Request	-	Major Site Plan Review for a new retail development
Location	-	3311 Secor Road
Applicant	-	Westgate Village North, LLC 30 N. Lasalle Street, Suite 2120 Chicago, IL 60602
Property Owner	-	Niki Toledo LP 11720 EL Camino Real, Suite 250 San Diego, CA 92130
Civil Engineer	-	Woolpert, Inc. 4454 Idea Center Boulevard Dayton, OH 45430
Architect	-	Civil & Environmental Consultants, Inc. 6200 Birdsong Road Concord, NC 28025

The staff recommends that the Toledo City Plan Commission approve SPR25-0059, a Major Site Plan Review for a New Retail Development at 3311 Secor Road, for the following three (3) reasons:

MAJOR SITE PLAN REVIEW
TOLEDO CITY PLAN COMMISSION
REF: SPR25-0059
DATE: February 12, 2026
TIME: 2:00 P.M.

SITE PLAN

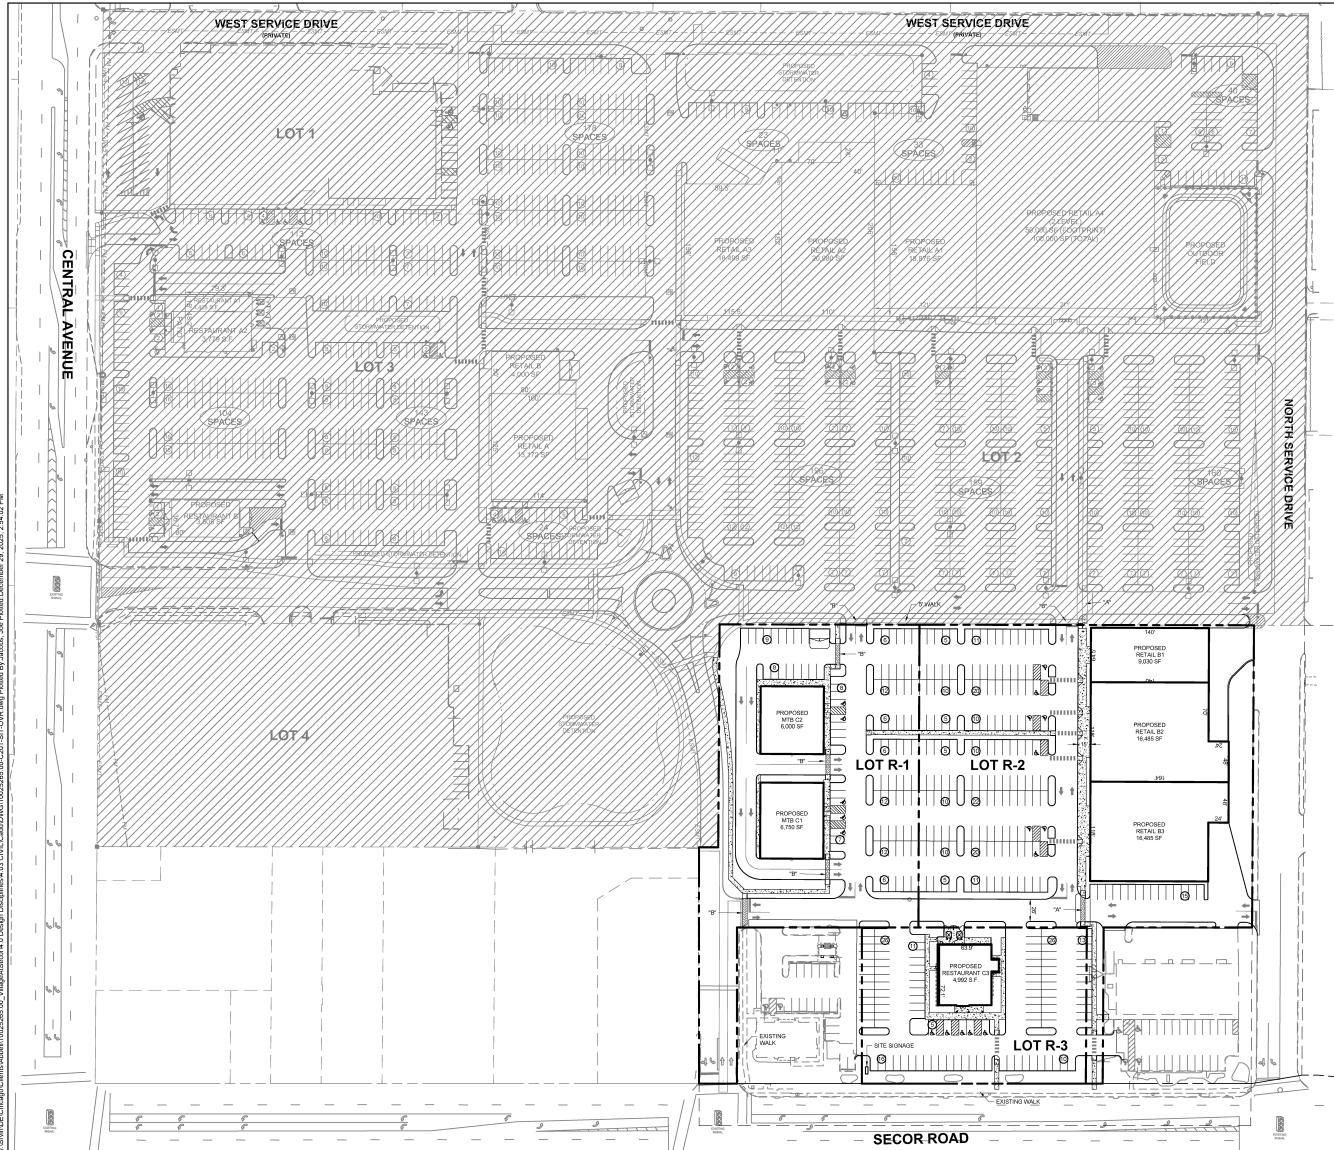
In addition to vehicle parking spaces, a minimum of one (1) bicycle parking space is required for every ten (10) vehicle parking spaces. No bicycle parking spaces have been depicted on the submitted plans. Each lot must provide a minimum number of bicycle parking spaces based on this calculation depending on the number of vehicle parking spaces on those lots in their final design. Each bicycle parking space must meet the standards of TMC§1107.0902. This has been added as a condition of approval.

TMC§1107.1000 requires a minimum of three (3) off-street loading spaces within this development. While no off-street loading spaces are delineated on the submitted plans, it appears there are areas for loading spaces on the north side of the building proposed on lot "R-2". The applicant shall submit a revised site plan depicting a minimum of three (3) off-street loading spaces as required by TMC§1107.1000. This has been added as a condition of approval.

It appears the buildings on lot "R-1" will include drive-thru facilities. The applicant must ensure these drive-throughs meet the minimum stacking requirements of TMC§1107.1600. The applicant shall submit a revised site plan depicting stacking spaces as required by TMC§1107.1600. This has been added as a condition of approval.

The submitted site plan does not show the dimensions of all drive approaches, driveways, drive aisles, and parking spots are required by TMC§1107.1900. The applicant shall submit a revised site plan depicting all drive approaches, driveways, drive aisles, and parking spots meeting the dimensional requirements of TMC§1107.1911. This has been added as a condition of approval.

Walkways within large-scale retail projects are required to connect focal points of pedestrian activity such as, but not limited to, transit stops, street crossings, building and store entry points, and shall feature items such as adjoining landscaped areas that includes trees, shrubs, benches, flower beds, planters, groundcover, or other such materials for no less than thirty percent (30 %) of its length. The proposed walkways attempt to achieve this requirement, but fall short in directly connecting the proposed restaurant on lot "R-3" to buildings on lots "R-1" and "R-2". A pedestrian crosswalk should also be added across the north-south drive aisle on lot "R-1" to complete the pedestrian connection between buildings on lots "R-1" and "R-2". Lastly, the pedestrian crosswalk across the east-west drive aisle in front of the "proposed restaurant" shall be aligned to not dead-end into a landscape island. Direct pedestrian walkway connections shall be added or altered resolving these connection issues. This has been included as a condition of approval.

All connecting walkways within large-scale retail projects must be a minimum of six feet (6') in width per TMC§1109.0304(A). All internal pedestrian walkways that cross parking aisles or driveways shall be distinguished from driving surfaces through the use of durable, low-maintenance surface materials such as pavers, bricks, scored concrete or scored and painted asphalt to enhance pedestrian safety and comfort. Raised walkways may be installed if elevated six inches (6") with tapered side slopes and meet ADA standards. A condition of approval has been included requiring compliance with these connecting walkway design standards.

TMC§1108.0202 *Frontage Greenbelt* requires a minimum thirty-foot (30') wide frontage greenbelt along Secor Road. This greenbelt must contain at least one (1) tree for every thirty linear feet (30') of frontage. A minimum of twelve (12) trees are required along Secor Road. The landscaping plan depicts nine (9) trees along Secor Road within what appears to be a fifteen foot (15') wide frontage greenbelt. The Plan Director has approved a fifteen foot (15') wide frontage greenbelt for this site because it is consistent with frontage greenbelts to the north and south along Secor Road. An additional three (3) trees shall be depicted on a revised landscaping plan. This has been listed as a condition of approval.

31. Each lot shall meet the parking maximum standards of TMC§1107.0300. **Not acceptable as depicted. The applicant shall either submit an acceptable alternative parking plan pursuant to TMC§1107.1400 or submit a revised site plan reducing the number of off-street parking spaces on each lot in compliance with TMC§1107.0300.**

32. Each lot shall provide one (1) bicycle parking space for every ten (10) vehicle parking spaces. Bicycle parking spaces shall meet the standards of TMC§1107.0900. **Not acceptable as depicted. The applicant shall submit a revised site plan depicting bicycle parking spaces compliant with TMC§1107.0900.**

33. Pursuant to TMC§1107.1000, a minimum of three (3) off-street loading spaces is required within this development. **Not acceptable as depicted. The applicant shall submit a revised site plan depicting a minimum of three (3) off-street loading spaces.**

34. Drive-through facilities must meet the minimum stacking requirements of TMC§1107.1600. **Not acceptable as depicted.**
35. Pedestrian connections shall be added or altered to resolve connection issues:

- a. A direct pedestrian connection shall be added between the building on lot "R-3" and the building on lot "R-2". **Not acceptable as depicted.**
 - b. A direct pedestrian connection shall be added between the building on lot "R-3" and the buildings on lot "R-1". **Not acceptable as depicted.**

- c. A pedestrian crosswalk shall be added on the western side of the pedestrian walkway connecting lots "R-1" and "R-2" to complete the direct connection. **Not acceptable as depicted.**

- d. The pedestrian crosswalk connecting the building on lot "R-3" to Secor Road shall be aligned to not dead-end into a landscape island.
36. All connecting walkways within large-scale retail projects must be a minimum of six feet (6') in width per TMC§1109.0304(A). **Not acceptable as depicted. The applicant shall submit a revised site and landscaping plan to the Plan Director depicting all pedestrian walkways with a minimum width of six feet (6').**

ANCHOR BUILDING ELEVATIONS

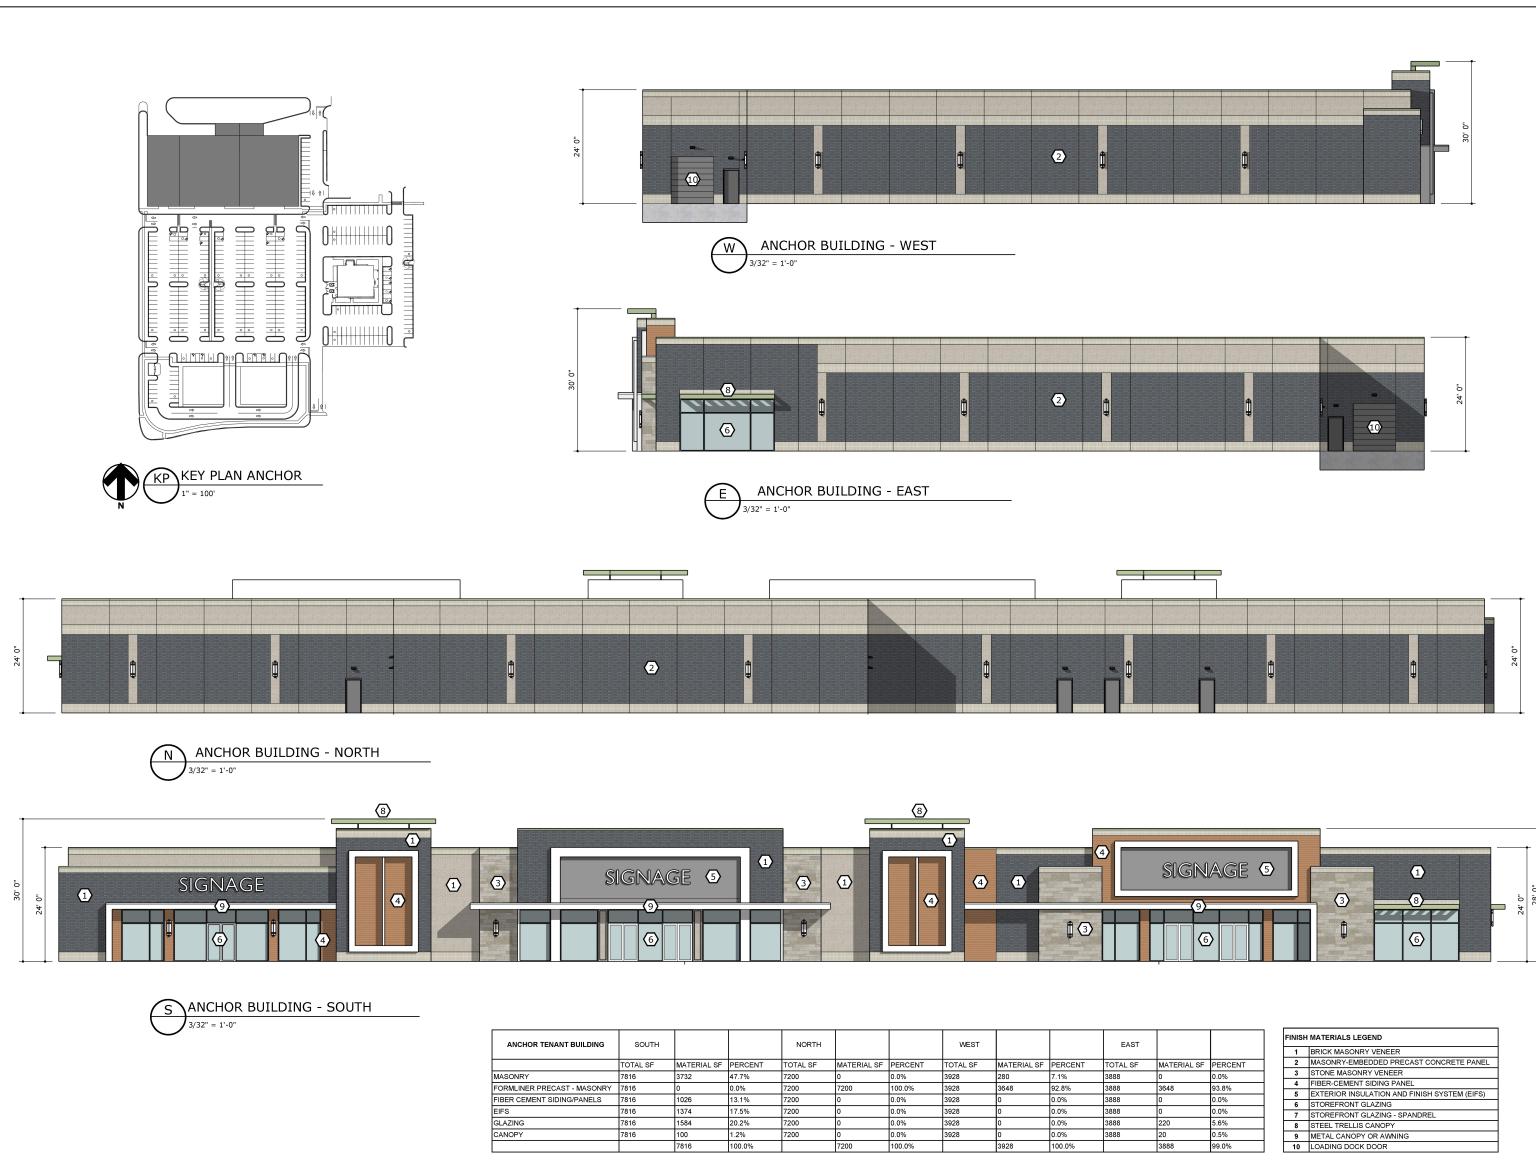
Building design is subject to the standards of TMC§1109.0306 which outlines design standards for large-scale retail projects. The standards are intended to promote the design of an urban environment that is built to human scale and to encourage attractive street fronts. A wall surface visible from adjoining streets or properties longer than 100 feet must incorporate a series of recesses or offsets, at intervals of not less than twenty-five feet (25') nor more than 100 feet, that vary the depth of the building wall by a minimum of four-feet (4'). Not less than twenty-five percent (25%) of the building wall shall be varied in this way. It appears each tenant space entrance has an offset which may meet this requirement on the provided elevations, but it is unclear from the flat building depictions on the site and landscaping plans. The applicant shall clarify that these building offsets are a minimum of four feet (4'). Even so, it appears the eastern façades of the anchor and “multi-tenant” buildings consist of a flat expanse without recesses or offsets. The applicant shall submit revised building elevation drawings depicting a recess or offset along these walls in compliance with TMC§1109.0306. This has been listed as a condition of approval.

TMC§1109.0500 establishes facade material and color standards for multi-family, commercial, mixed use, institutional, and large-scale retail projects. At least eighty percent (80%) of each elevation visible from the right-of-way must be comprised of predominant materials such as brick, stone, or glass. No more than twenty percent (20%) of the same may be comprised of accent materials such as stucco, fiber cement board, EIFS, or vinyl. The anchor building has three (3) elevations which are visible from the right of way: the north, east, and south elevations. The north and east elevations are comprised of one-hundred percent (100%) predominant materials (masonry-embedded concrete cladding, windows), which is acceptable for this code section. However, the south elevation is comprised of sixty-nine percent (69%) predominant materials (masonry and windows) and thirty-one percent (31%) accent materials (EIFS and fiber cement). As a condition of approval, the applicant shall submit revised elevation drawings for the anchor building showing compliance with TMC§1109.0500.

51. A wall surface visible from adjoining streets or properties longer than 100 feet must incorporate a series of recesses or offsets, at intervals of not less than twenty-five feet (25') nor more than 100 feet, that vary the depth of the building wall by a minimum of four feet (4'). Not less than twenty-five percent (25%) of the building wall shall be varied in this way. **Applicant shall submit elevation drawings clarifying that building offsets are a minimum of four feet (4') in depth. Applicant shall also submit revised elevation drawings depicting a recess or offset in the building plane along the eastern elevations of the "Anchor Retail" and "Multi-Tenant" buildings in compliance with TMC§1109.0306.**

- a. **The southern portion of the “Anchor Building” is not acceptable as depicted. The applicant shall submit revised elevation drawings to the Plan Director showing compliance with TMC§1109.0500.**
